CITY OF  
**PALO  
ALTO**

## Architectural Review Board Staff Report

3300 El Camino Real [21PLN-00028]: Ad-Hoc Committee Review of Previously Approved Project to Review Architectural and Landscape Element Design Changes

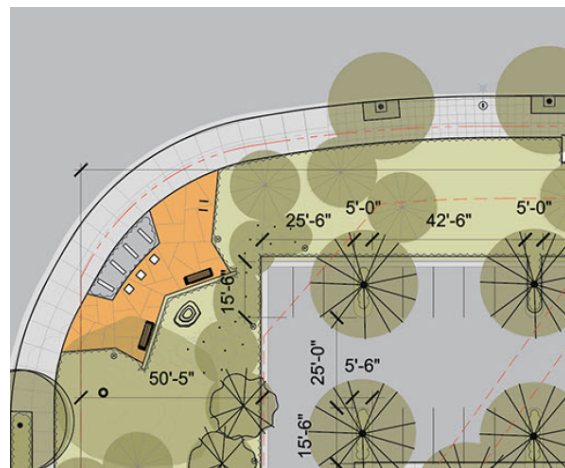
#### A. Enhanced Landscape on El Camino Real Frontage

The ARB recommended that the applicant enhance their landscape plan along the El Camino Real Frontage to incorporate a linear park to activate the street and better respond to El Camino Real Design Guideline 2.3.1.2 and 3.2.5.

The applicant has expanded the size of the corner pedestrian plaza at Hansen Way and El Camino Real and added fixtures to attract pedestrians to use the space. However, to create a linear park, staff would suggest the applicant add a decomposed granite (DG) walkway from the corner plaza to the front entrance plazas. The applicant has stated this is infeasible.

See the attached drawings for refinements to the landscape strip design along El Camino Real.

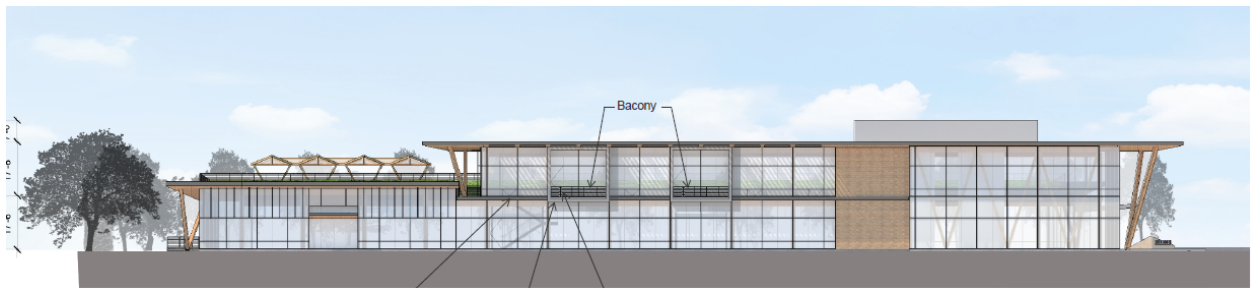
#### B. Consider Adding Texture to El Camino Real Façade

The ARB recommended that the applicant modify their existing façade on El Camino Real to incorporate additional textures to add additional articulation to the street facing side of the building.

The applicant has provided the requested modifications.

See the attached drawings for the proposed changes to the façade facing El Camino Real. Two new framed balconies are proposed on the second floor that provide for greater articulation and visual texture to the façade.

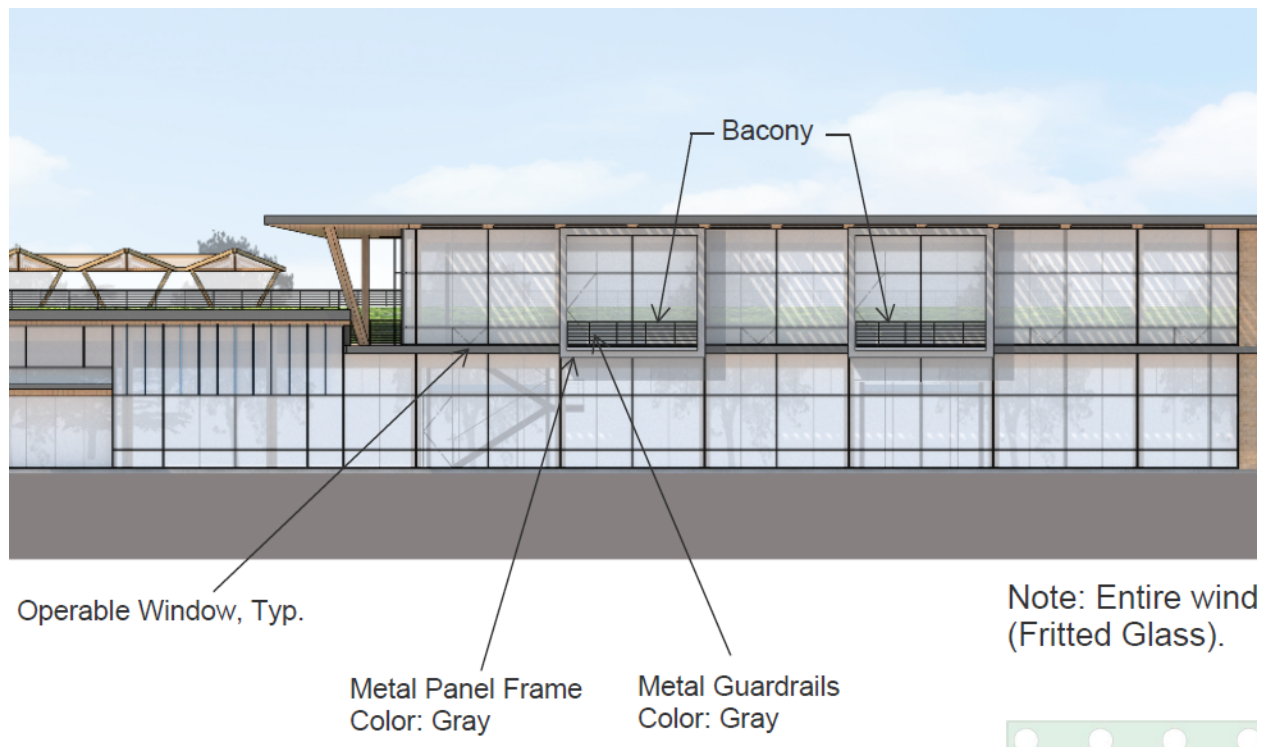
#### D. Add Operable Windows to the Building

The ARB recommended that the applicant incorporate operable windows into the design of their building.

The applicant has provided the requested windows on the El Camino Real façade. There does not appear to be any added windows on other façades.

See attached drawings for the proposed locations of the added operable windows on the second floor along the El Camino Real façade.
